A RESOLUTION OF THE CITY COUNCIL OF THE CITY OF MERCED, CALIFORNIA, ADOPTING THE MERCED VISION 2030 GENERAL PLAN

**MERCED VISION 2030 GENERAL PLAN
OPTION 2**

Proposed Changes Since August 2010 Public Review Draft

UC Merced Campus & University Community North Land Use Map

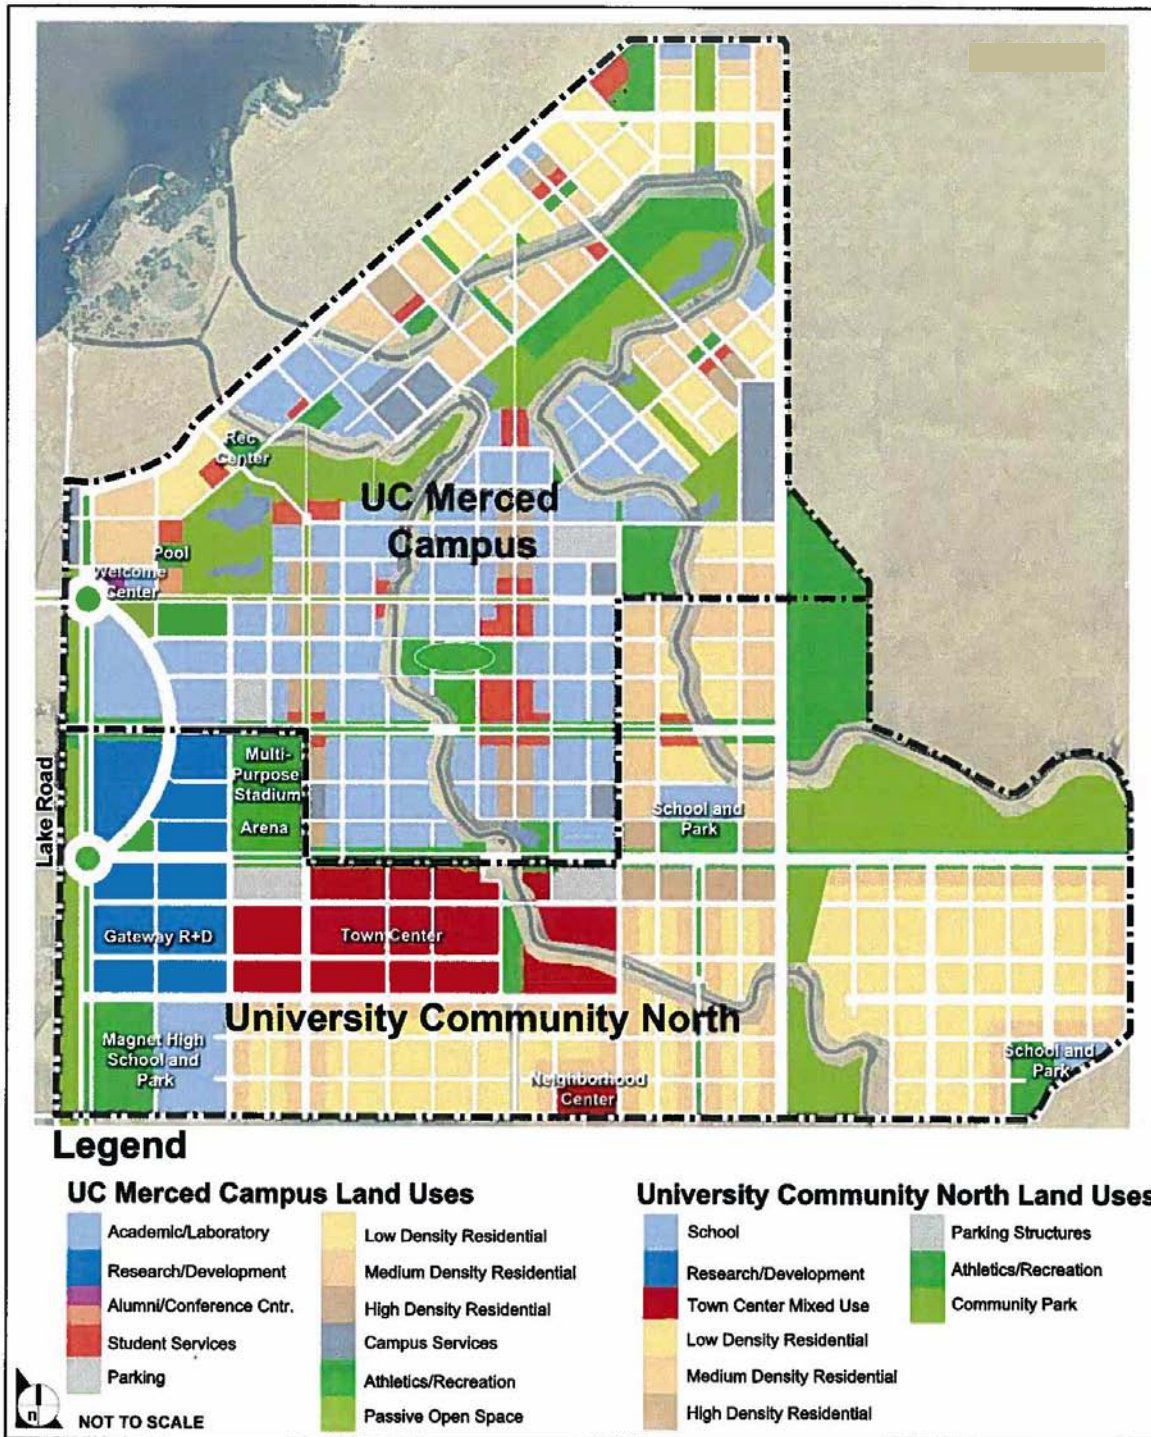
#	Pg.	¶	Col.	Change	Source
1	--	--	--	Various Figures, Maps, and Table throughout the General Plan document will be modified to reflect the 2009 UC Merced and University Community North boundaries as adopted by the UC Board of Regents in 2009. This will include changes to the Land Use Diagram and SUDP/SOI boundary for those areas only. See Exhibit 1 for the 2009 UC/UCP boundaries.	CS/UC

Figure 4.27f
Yosemite Avenue (East of Parsons/Gardner) Special Section

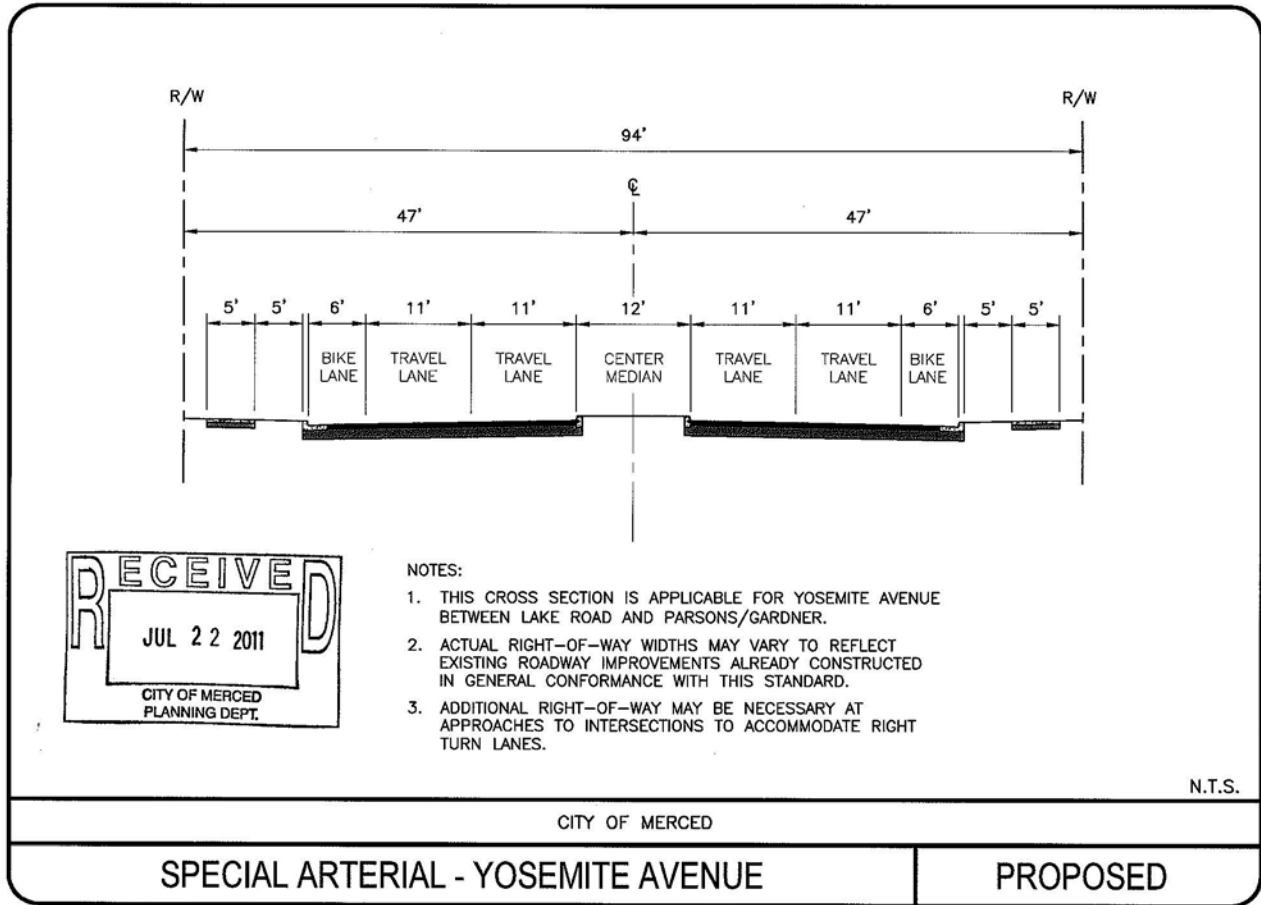
EXHIBIT 4

Land Use Diagram - Option 2 Sectors for Adoption

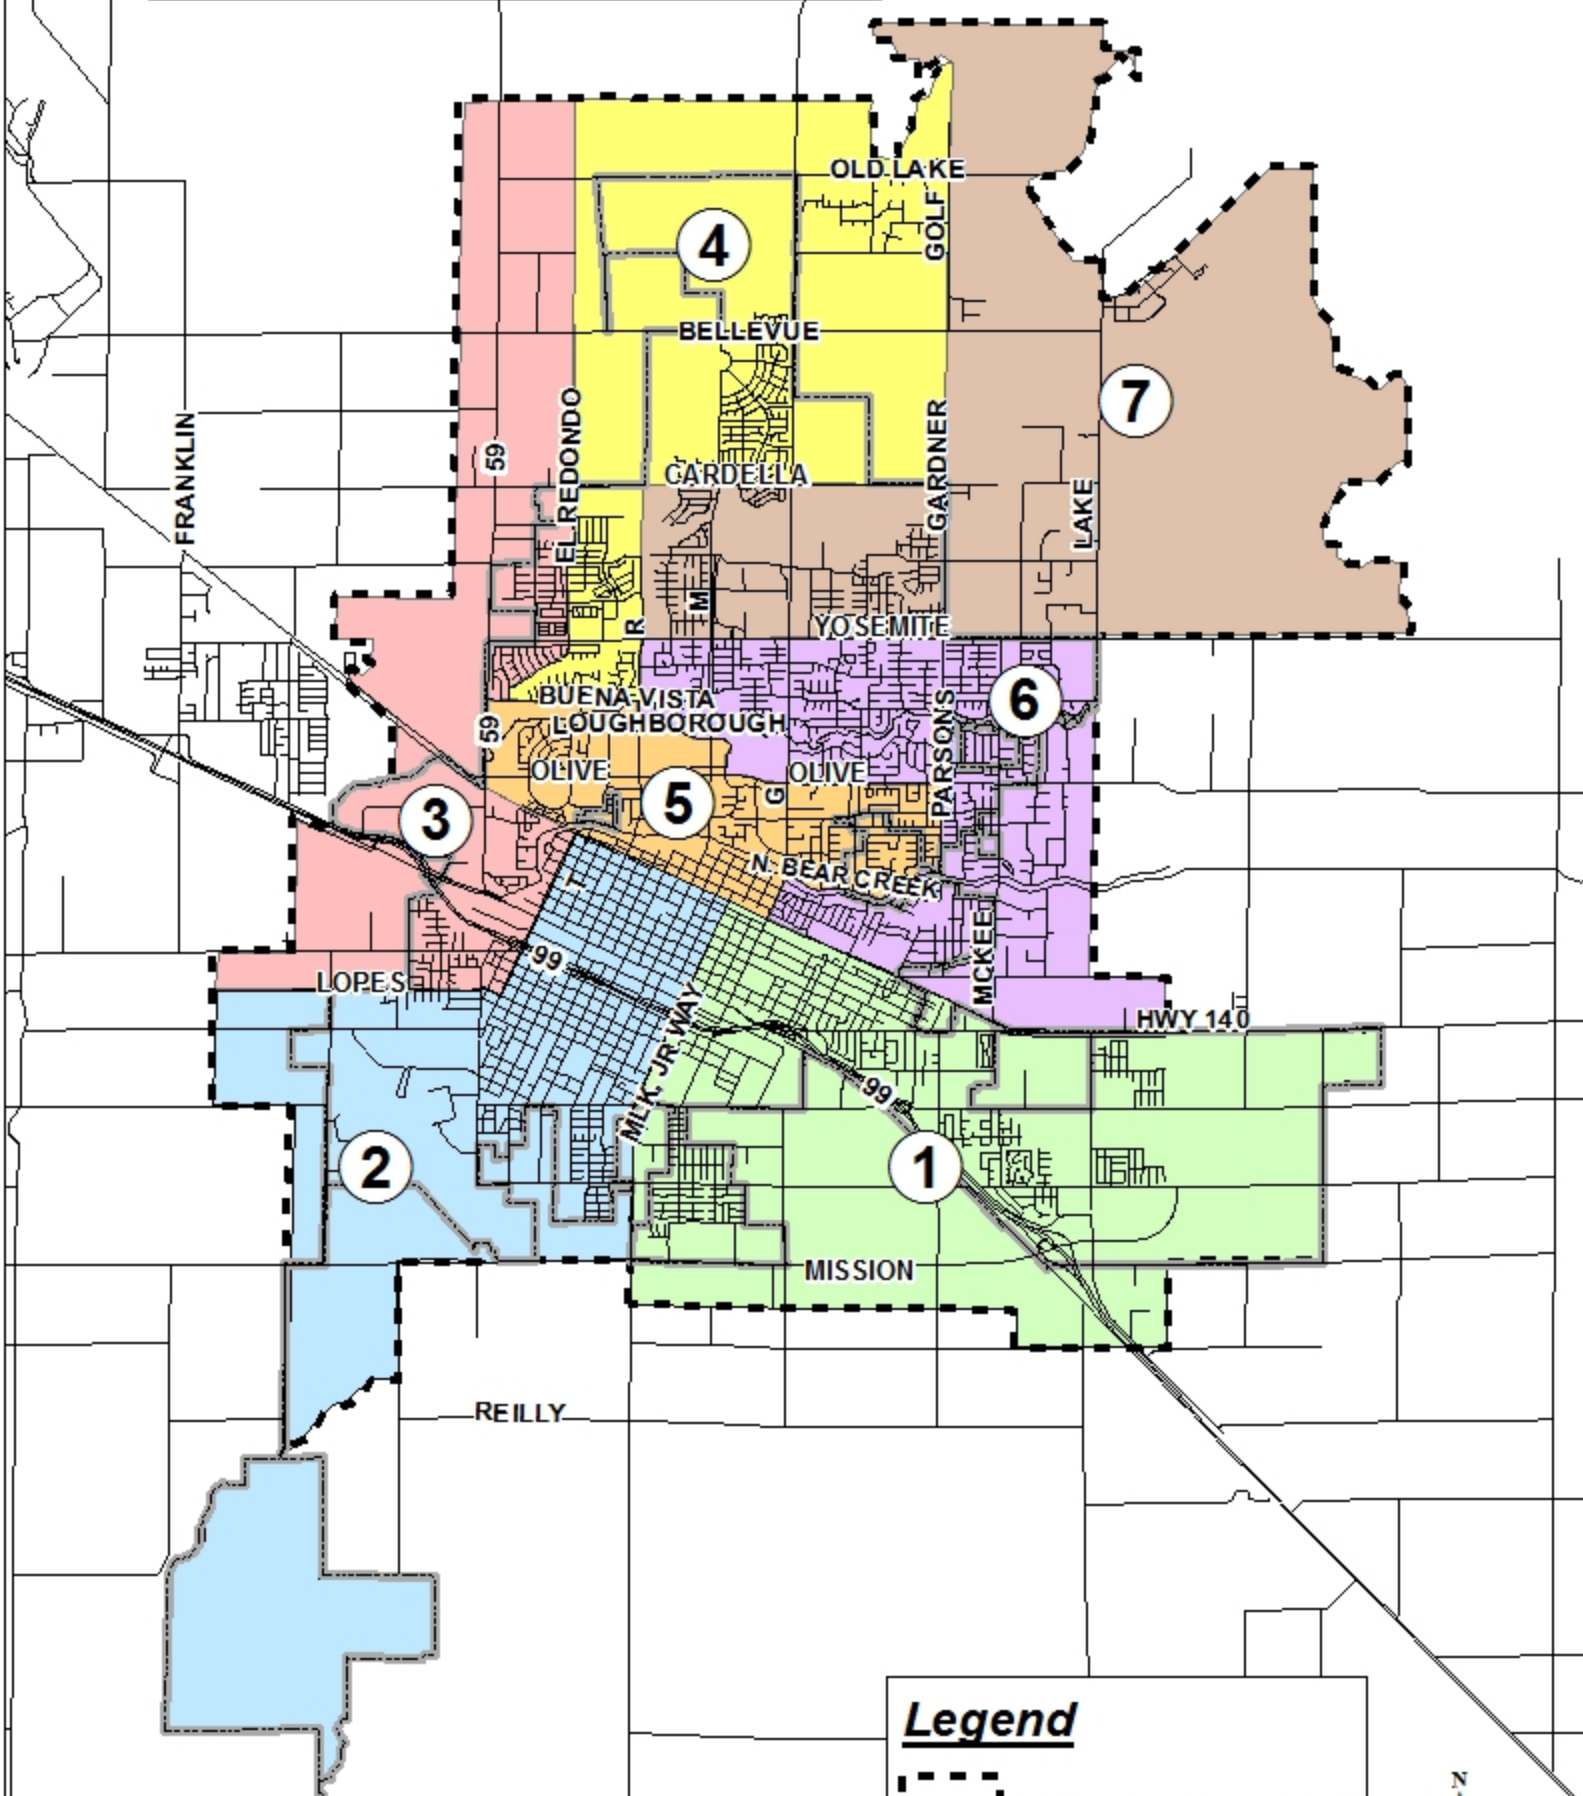
SECTION 3. The *Merced Vision 2030 General Plan* Land Use Diagram (Modified Figure 3.1 of Exhibit A) as divided into the seven sectors outlined in Exhibit D and with the changes as outlined in Exhibit C is hereby adopted.
